REPORT TO CITY OF VISALIA PLANNING COMMISSION

San Marino Tentative Subdivision Map No. 5594: A request by 4Creeks, Inc. to subdivide a 4.30-acre parcel into 22 lots for residential use and one out lot for future block wall and landscaping purposes in the R-1-5 (Single-Family Residential, minimum 5,000 square foot lot size) zone. The site is located on the northeast corner of North Shirk Street and the future West Delaware Avenue alignment. (Address: not yet assigned) (APN: 000-015-283).

Site Plan Review No. 2022-061-B:

Exhibit A

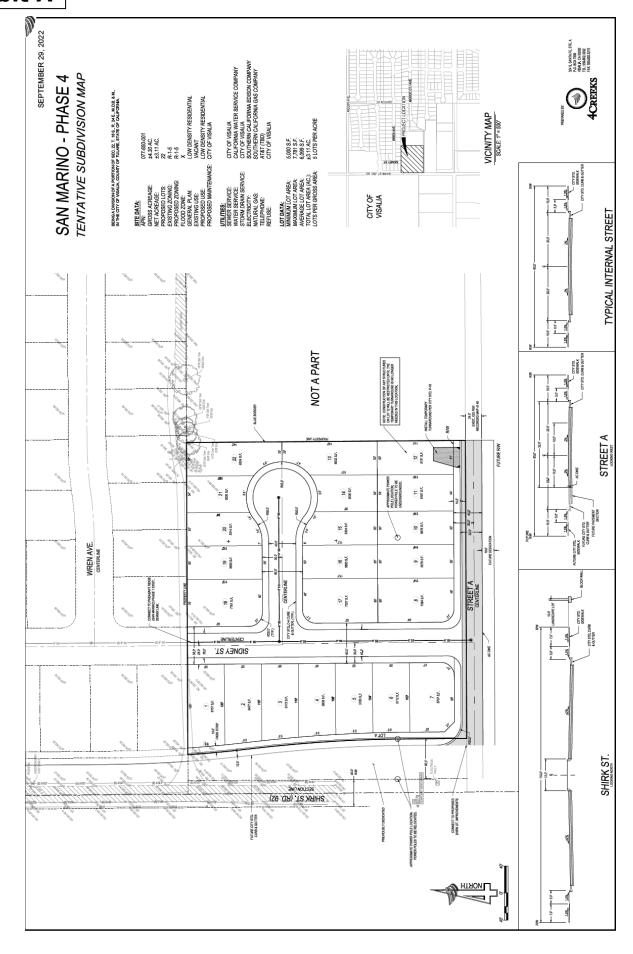
- 1. Install curb ramp returns based on street classification. 20' radius for local, 30' for arterial. >> Street "A" connection to Shirk is a typical local street connection therefore a 30' radius return is required and not 35' as shown on site plan.

- 2. Standard development fees apply for acreage and SFD units. >> Still applies.
- 3. Underground poles where allowable, relocate where necessary. >> Still applies. Existing utility poles on east side of Shirk appear to be distribution lines therefore Developer shall underground as part of project requirements and not relocated as per callouts on Site Plan.

- 4. Sidney is old local road standard. Widen to current city standard with full width achieved at intersection of new street from the north going south. All other local streets shall be full width to current standards. >> Appears to comply. Although CL is offset, construction of street crown shall not be modified.

- 6. Show all oaks; it appears that there may be oaks along south and east side of project. >> Still applies, ensure construction around existing oaks complies with City stds. Provide oak tree performance bond.

- 8. There is a 2-foot discrepancy between the provided Shirk cross section and the subdivision layout. Layout indicates a 10-foot width from curb face to ROW when it should be 12-feet. Adjustments are necessary, revise accordingly.

- 13. Show method of sewer collection. >> Provided. Additional SS extension necessary in Street "A" for future service to parcel to the east. It is recommended Project coordinate with City CIP PM for possible connection/extension from SS trunk line in Shirk. There is a sewer main shown across a portion of Lots 18 & 19 that appears to be in error.

- 16. This subdivision doesn't appear to be tied to previous developments, it will be entitled as a new subdivision. >> Still applies.
- 17. Provide storm drain collection for south side of Street "A" whether temporary or permanent.
